#### **ADDENDUM NO. 004**

Brighton Wastewater Treatment System Upgrades

June 2, 2025

SCALE: 1:75

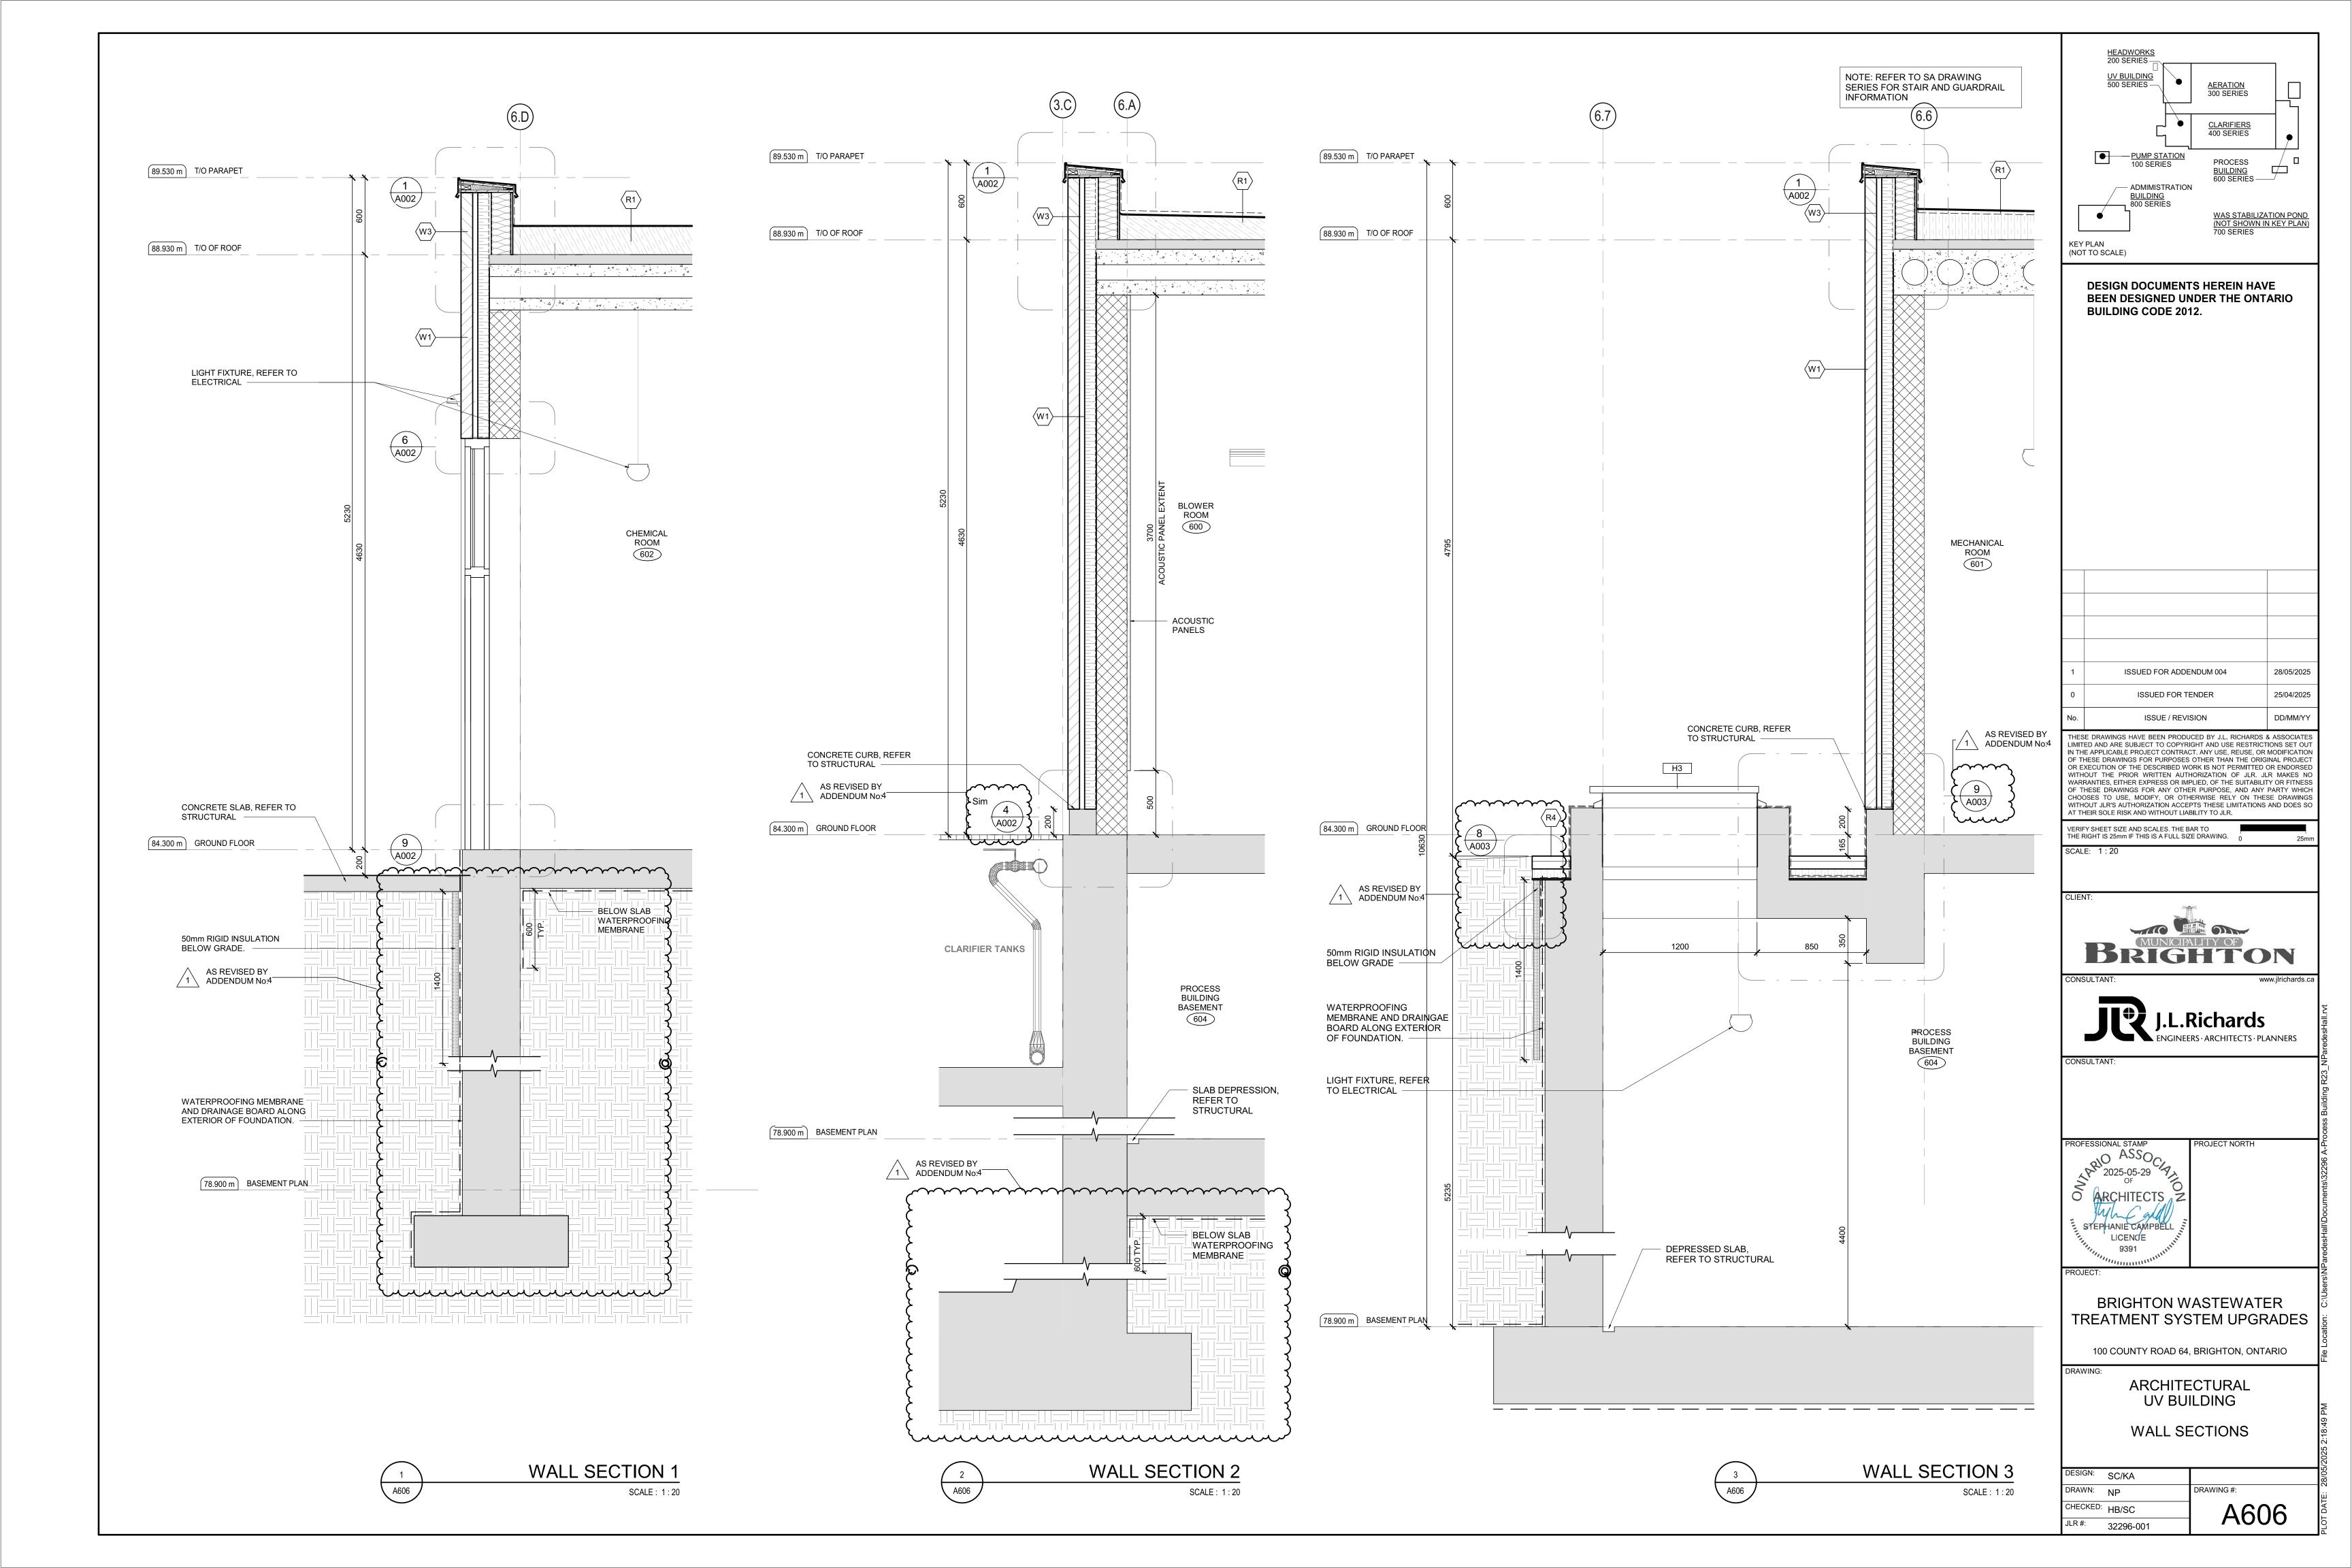
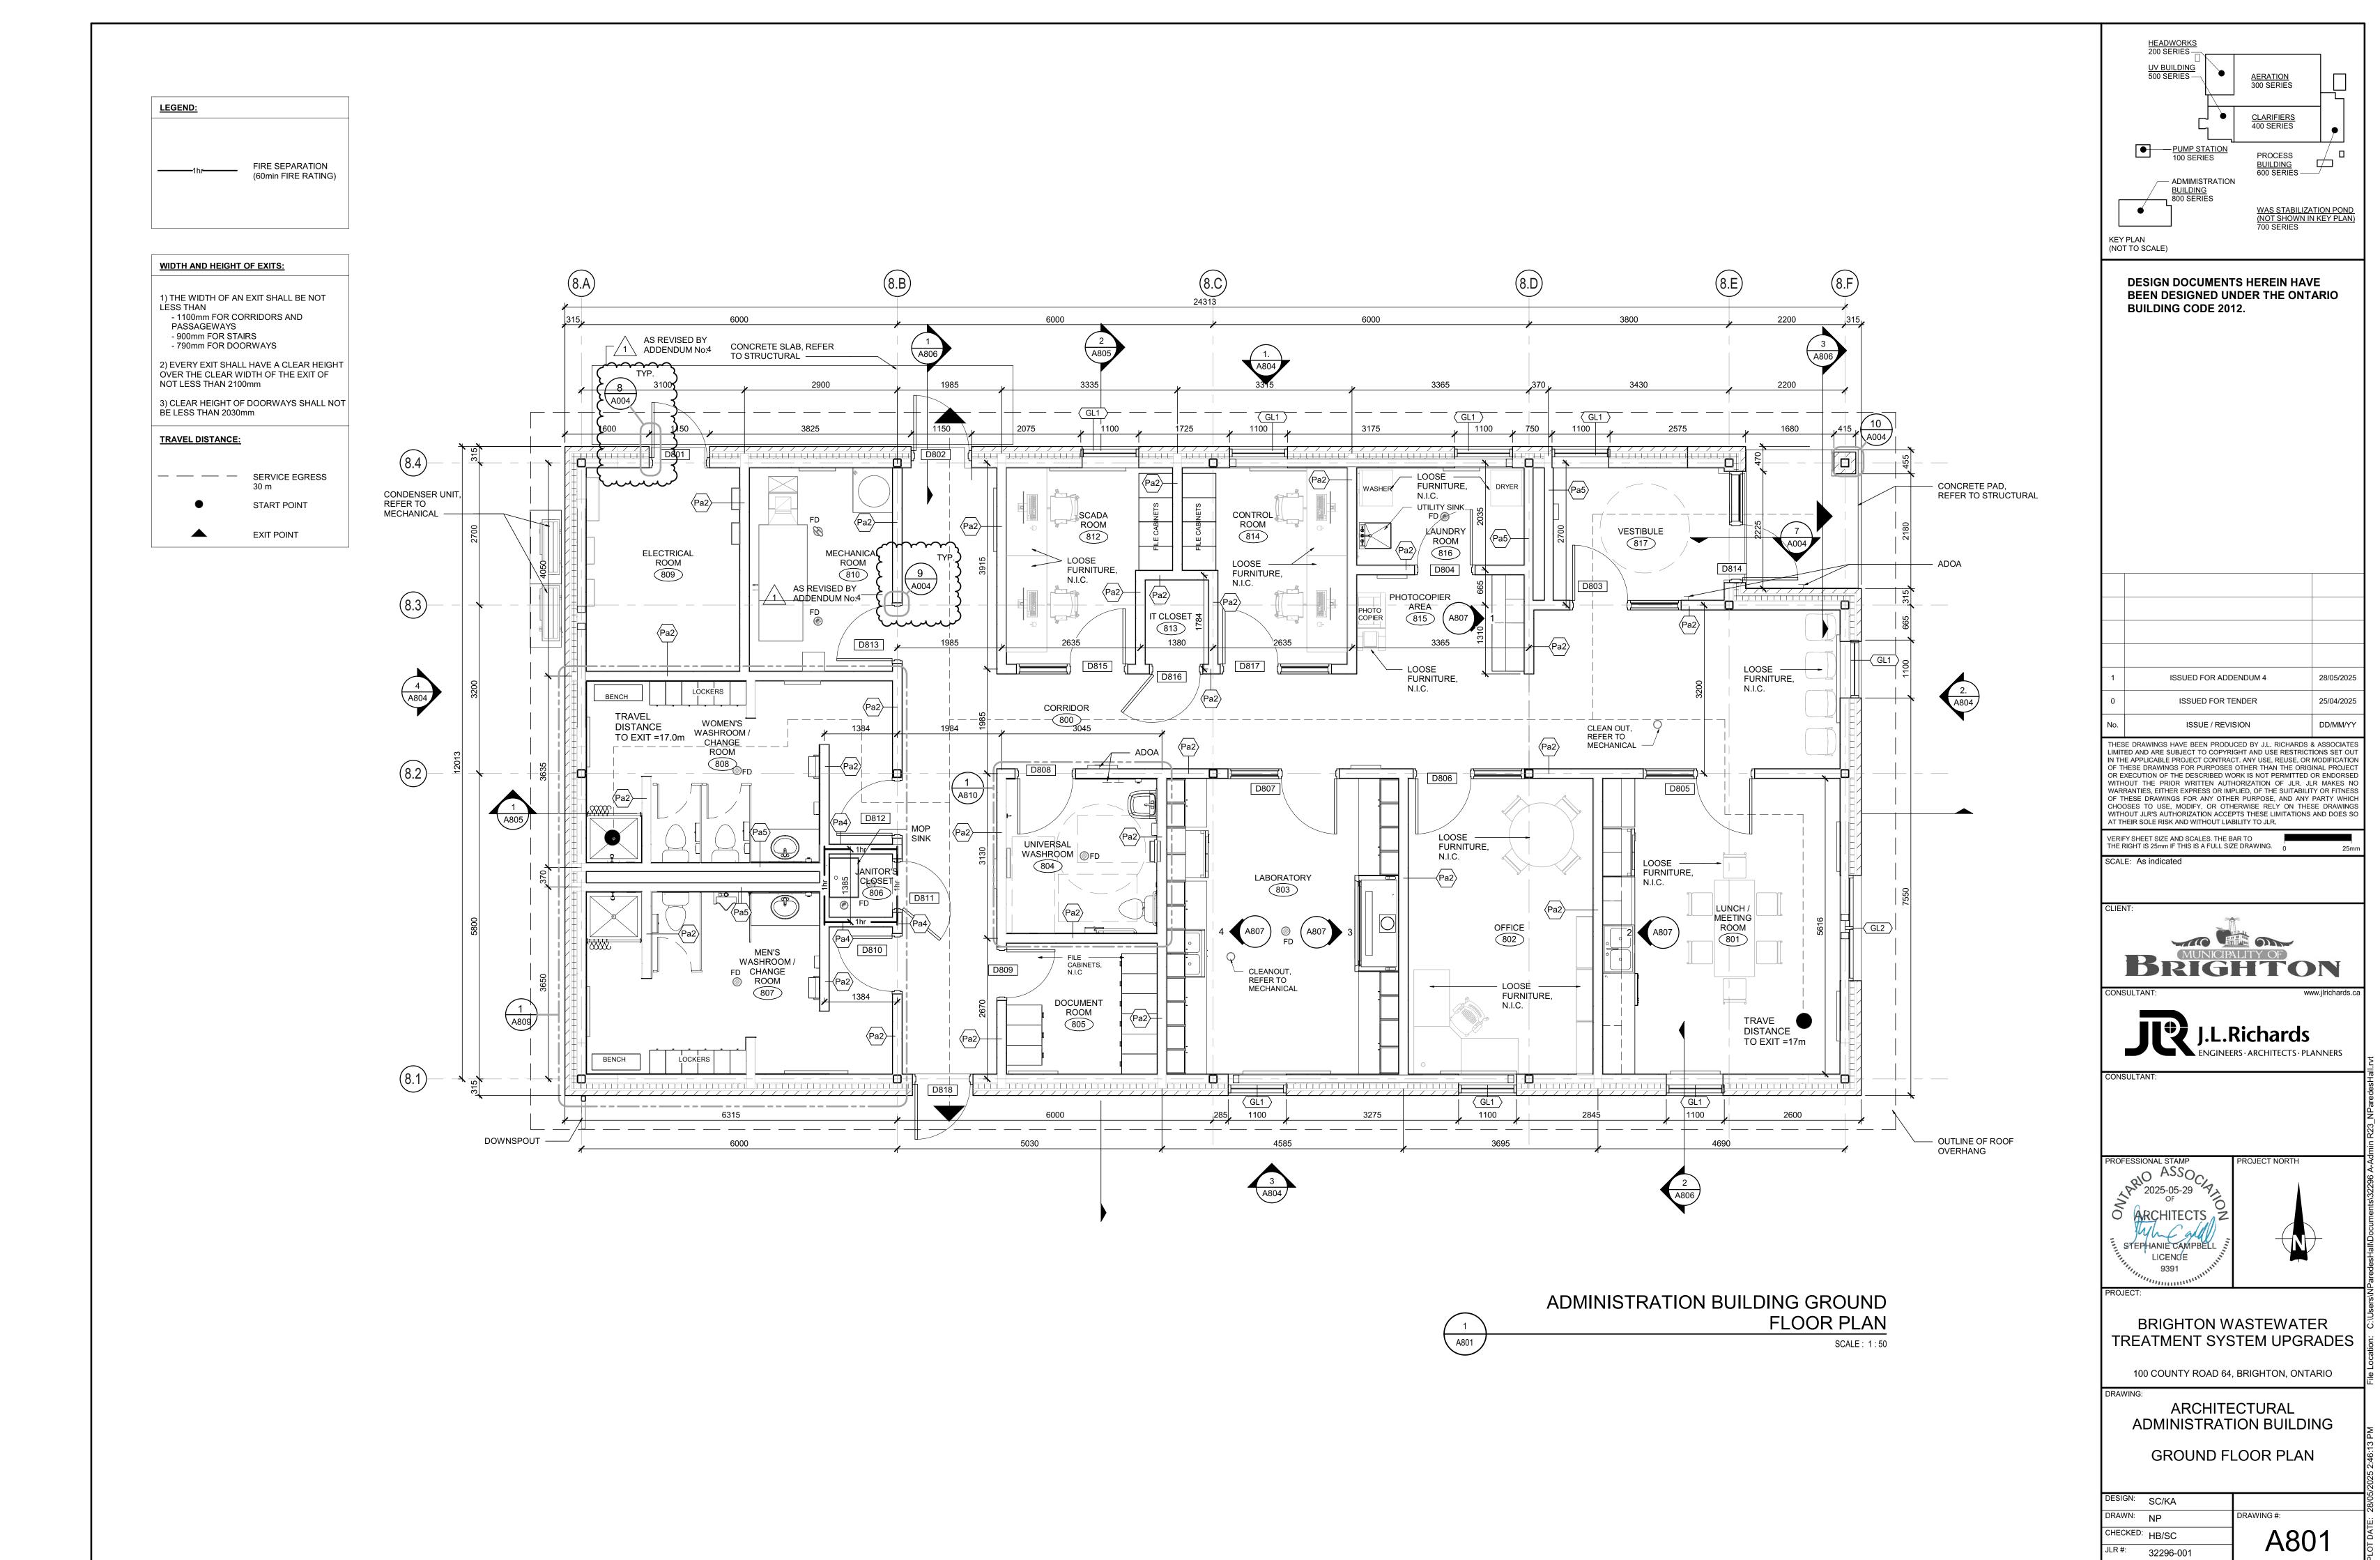
- 12.1 Detail #1
  - .1 **Revise** below grade waterproofing extension as bubbled
  - .2 Add detail 4/A002 callouts and 1/A002.
- 12.2 Detail #2 and #3
  - .1 Add detail 4/A002 callouts and 1/A002.

- 13.1 Detail #1
  - .1 **Revise** below grade waterproofing extension as bubbled.
- 13.2 Detail #2
  - .1 **Remove** below grade waterproofing extension as bubbled.
  - .2 Revise detail 2/A002 callout to read detail 4/A002.
